RamKeeper Modification for Apple IIGs 1 Meg (Rev. 3 Motherboard)

Swap the 74F27
if you have the earlier IIGS

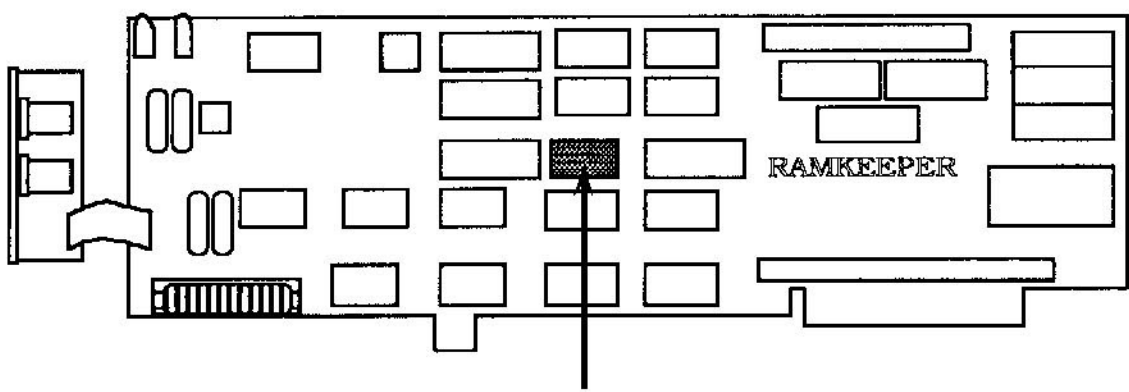
If you have the *earlier* GS, substitute the 74F27 chip shown below.

If you aren't familiar with the process of changing chips, refer to the "Chip Replacement Instructions" sheet included in the chip package.
